Director's Report

Project Name: Comfort Care White Lake
 Description: Rezoning & Preliminary Site Plan Approval
 Date on Agenda this packet pertains to: May 19th, 2022

RE: Comfort Care Assisted Living- Preliminary Site Plan Review – 4th Review

RE: Comfort Care
Rezoning and Preliminary Site Plan – Review #4

NOTE: FOR PLANTING REQUIREMENTS AND LANDSCAPE DETAILS REFER TO SHEET C500.

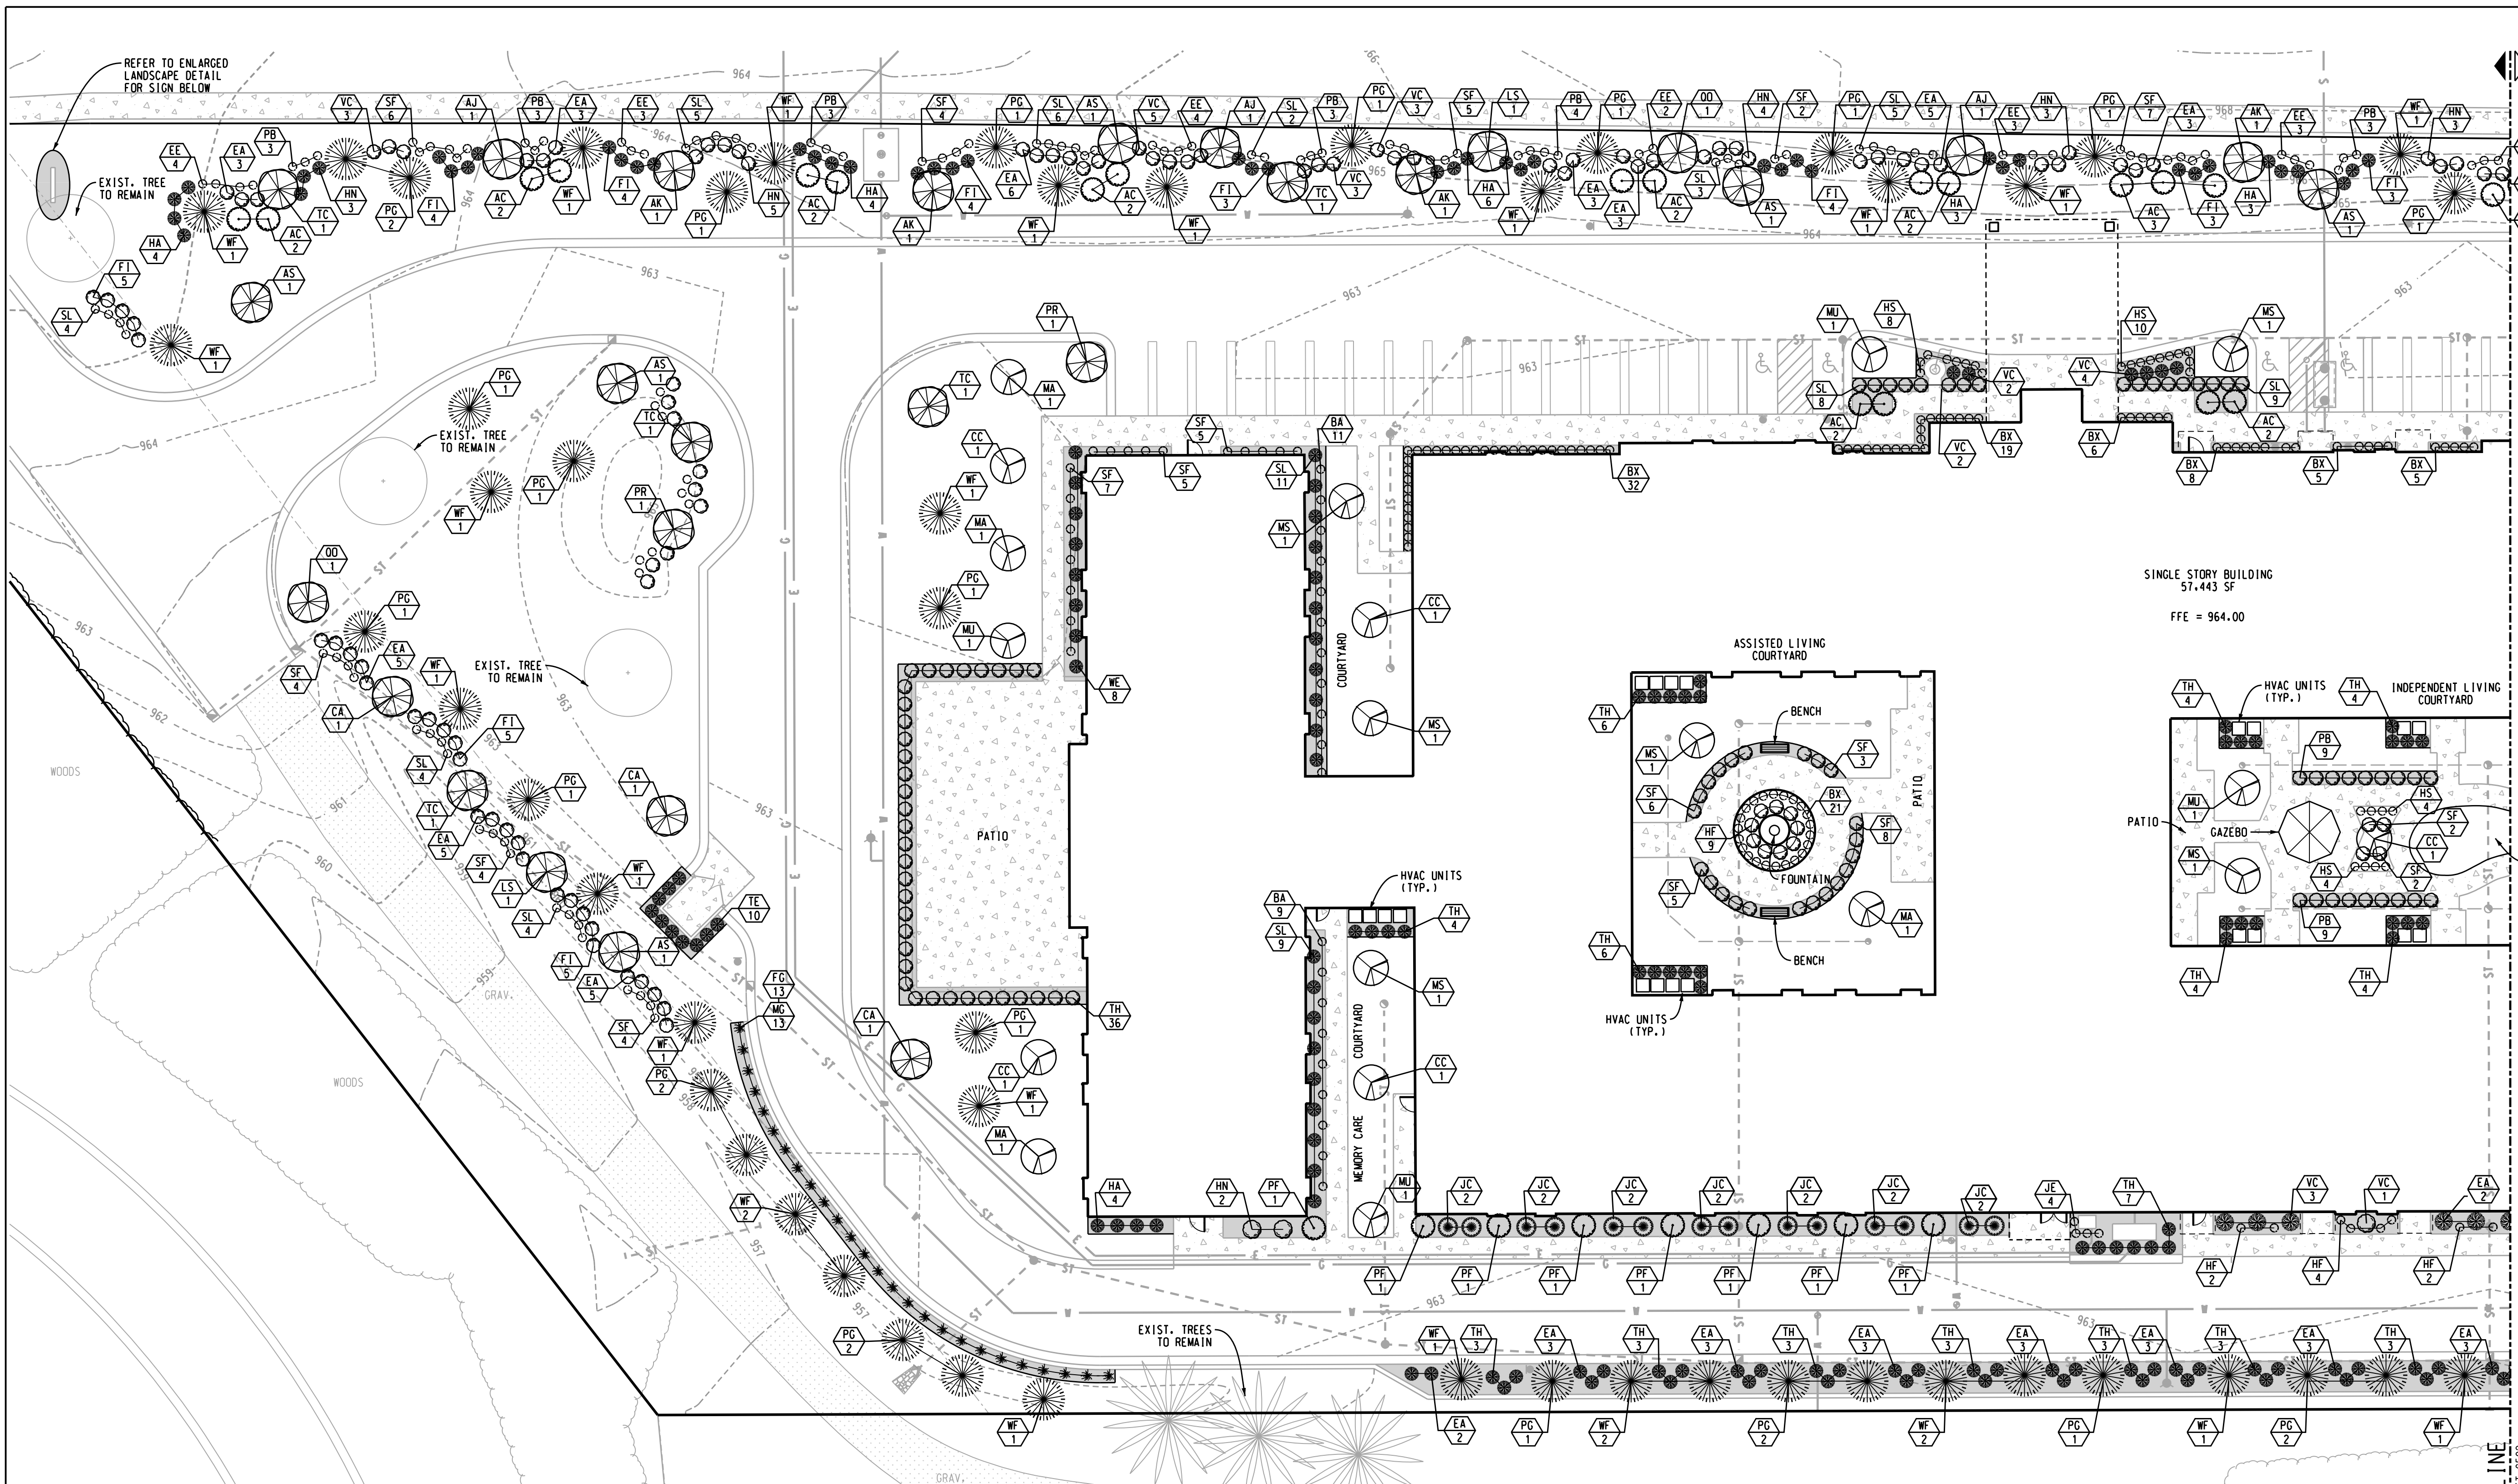
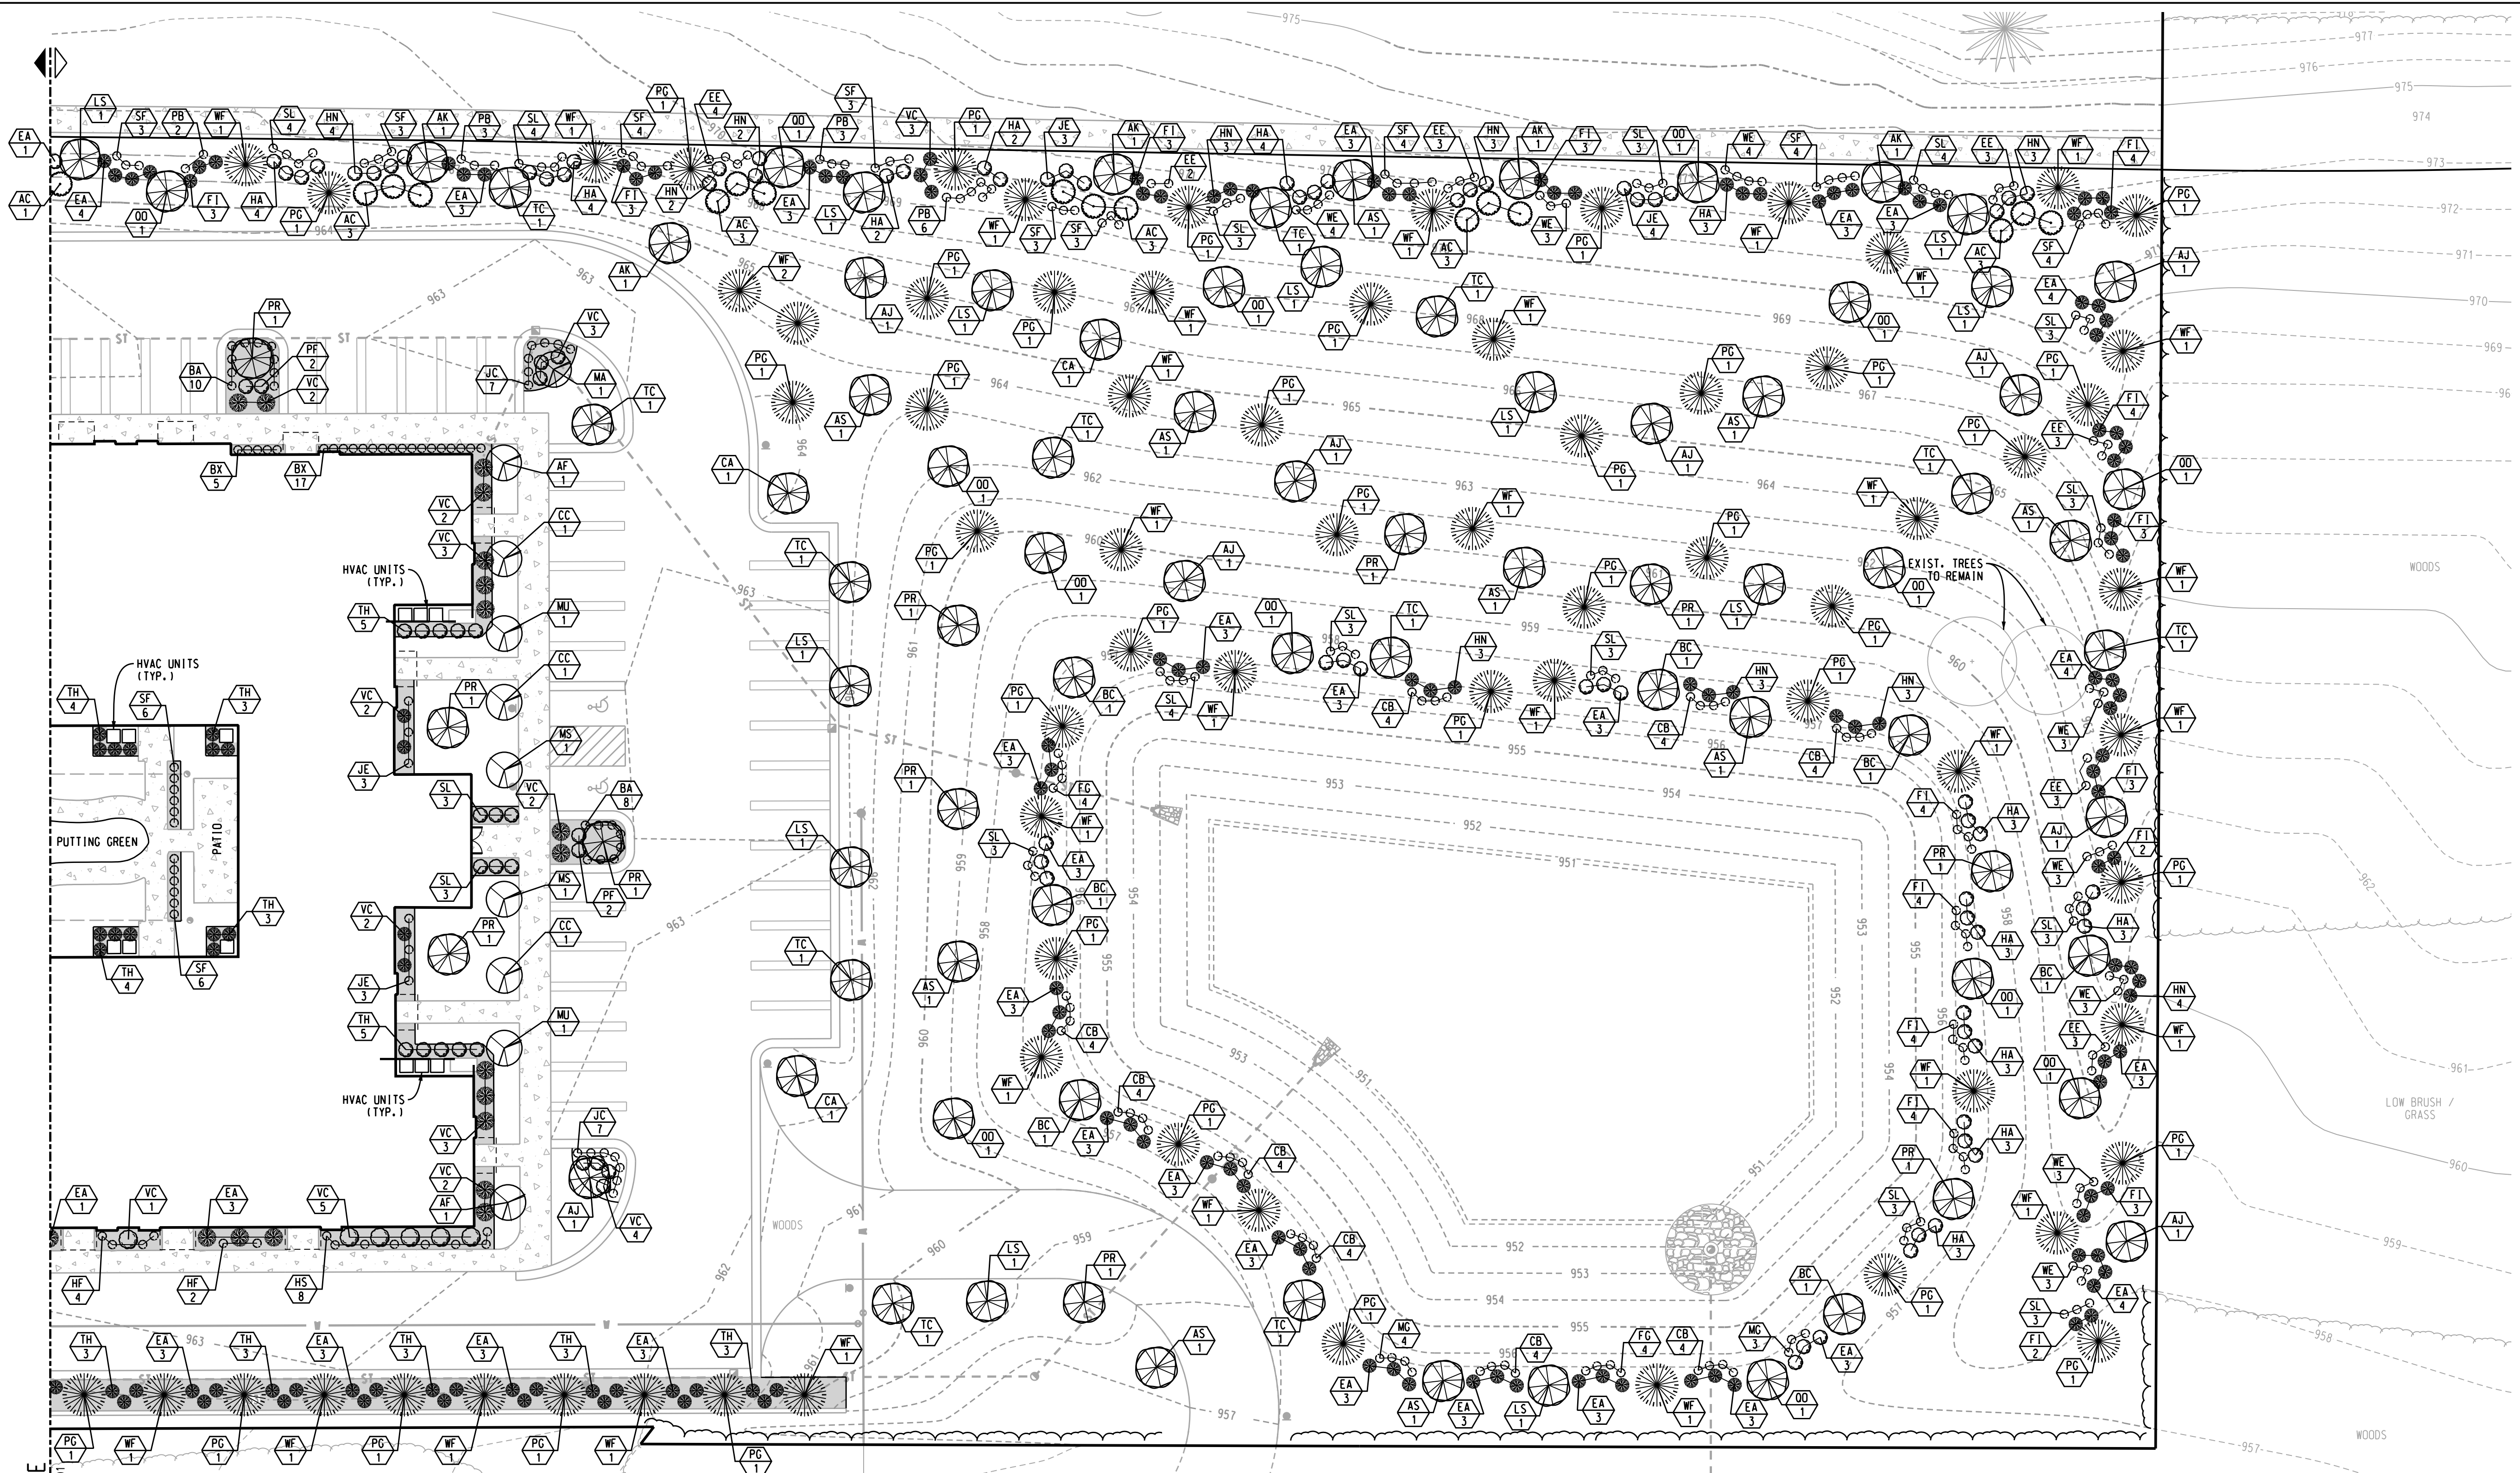
- Note 9 on the landscape plan mentions mulch. Sheet C500 also contains a mulch and edging detail. The zoning ordinance states the mulch product itself shall be at least doubled-shredded quality. **Revise accordingly.**

- The Planting Requirements table on Sheet C500 shall be revised to indicate the screen wall requirements for the 'Residential Buffer (west side)' minimum requirement.

CONCEPTUAL EAST ELEVATION
1" = 20'-0"

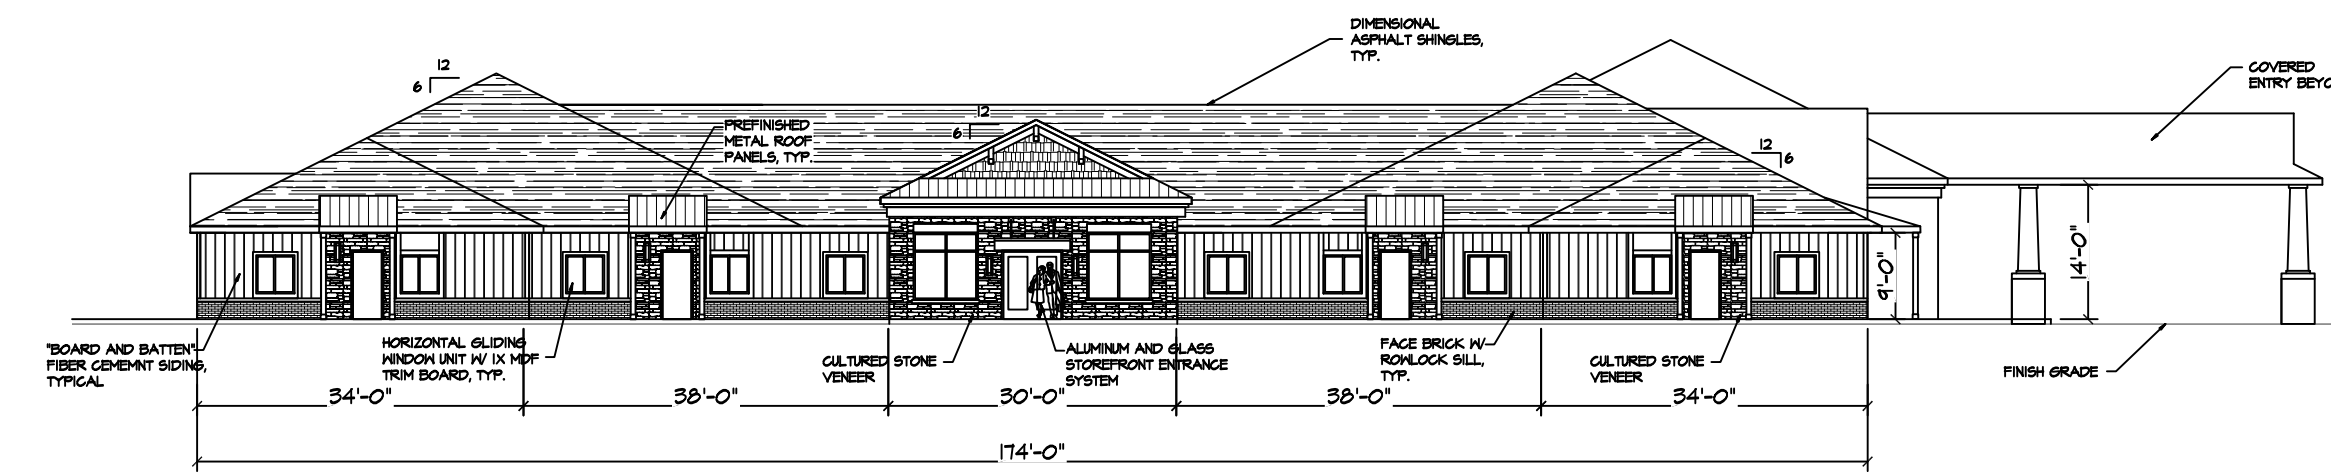
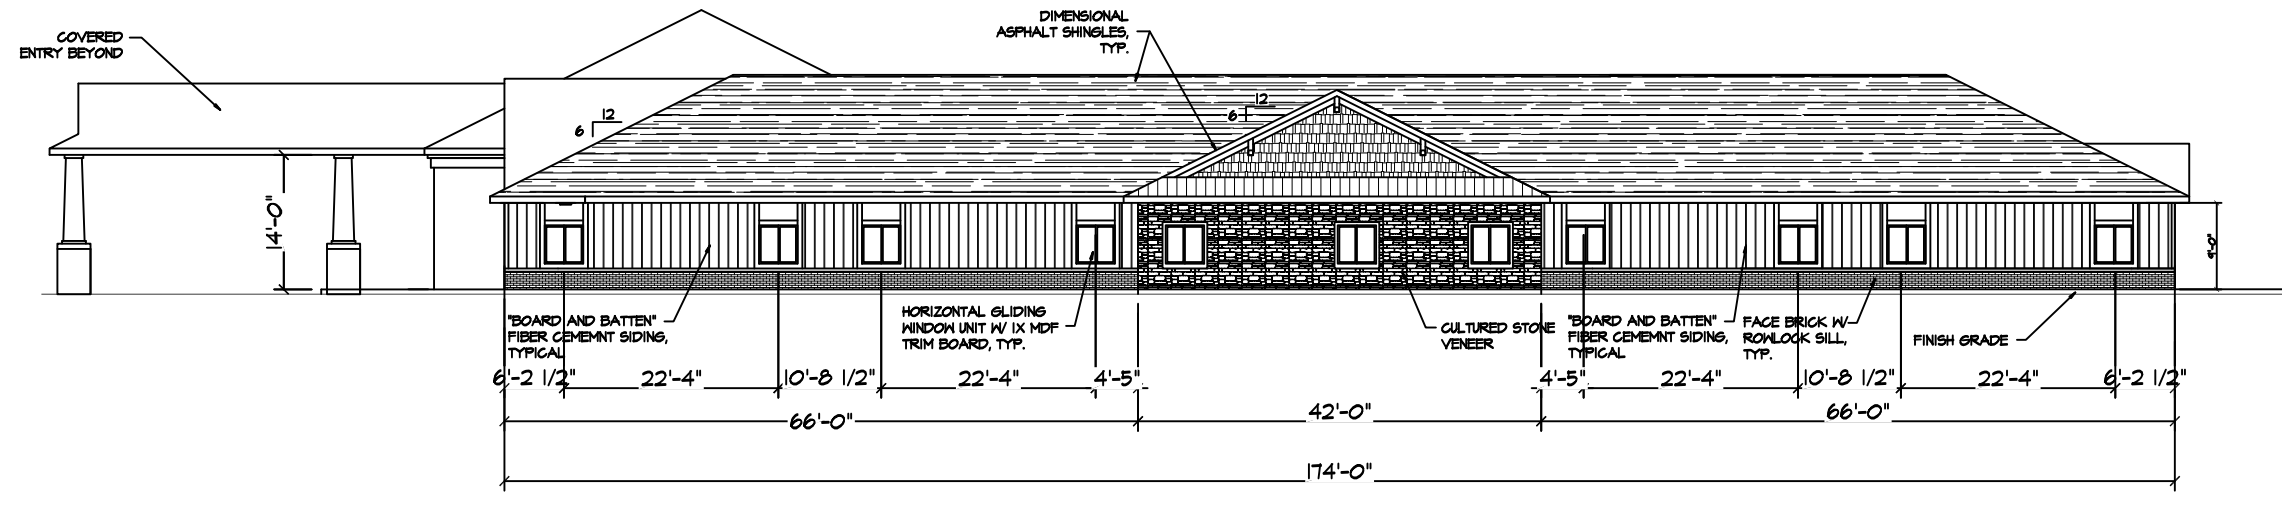
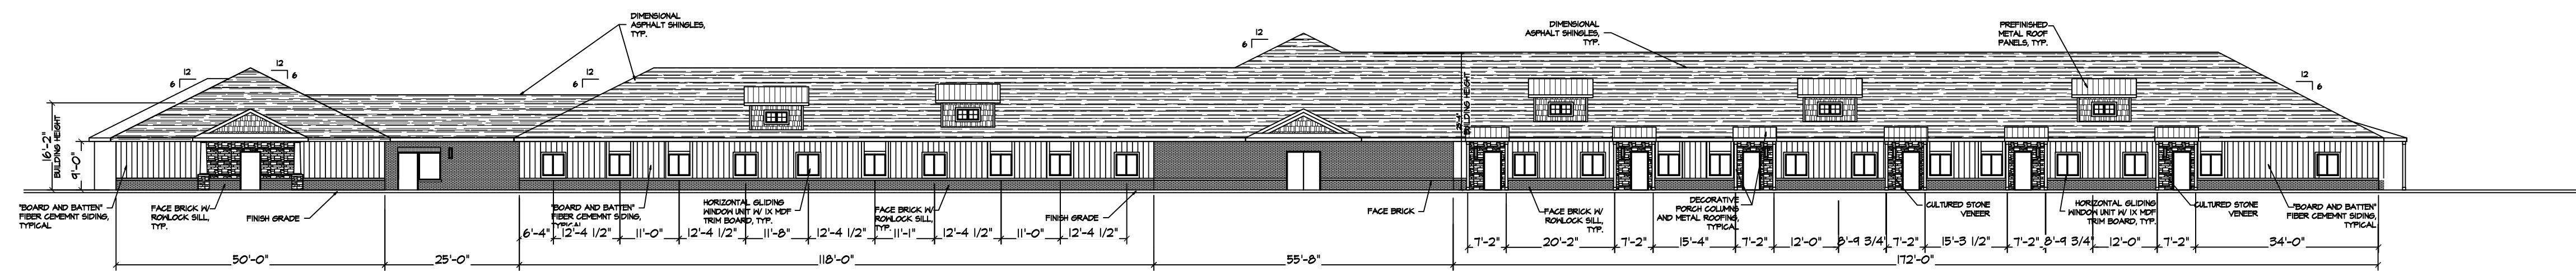
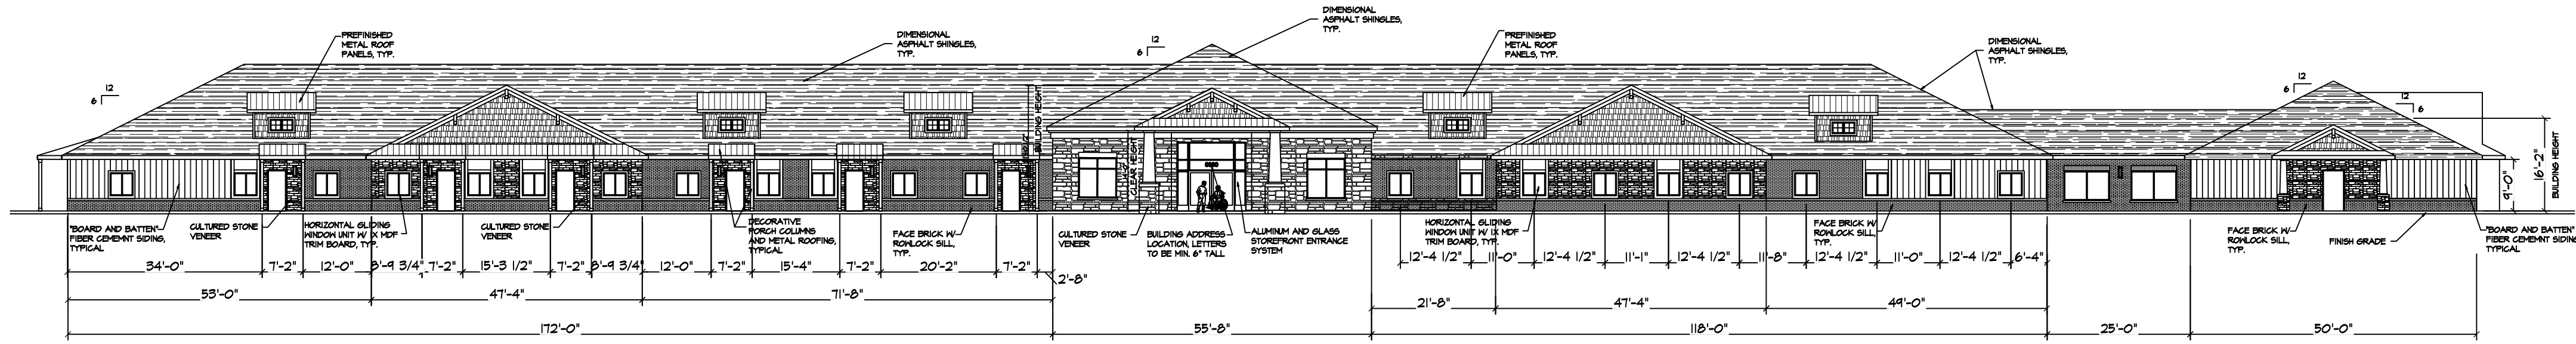
- The Developer’s architect previously indicated there would be bay windows across the front of the building. **Bay windows are not labeled on Sheet A1 or Sheet A2; clarify if bay windows are proposed and revise accordingly.**
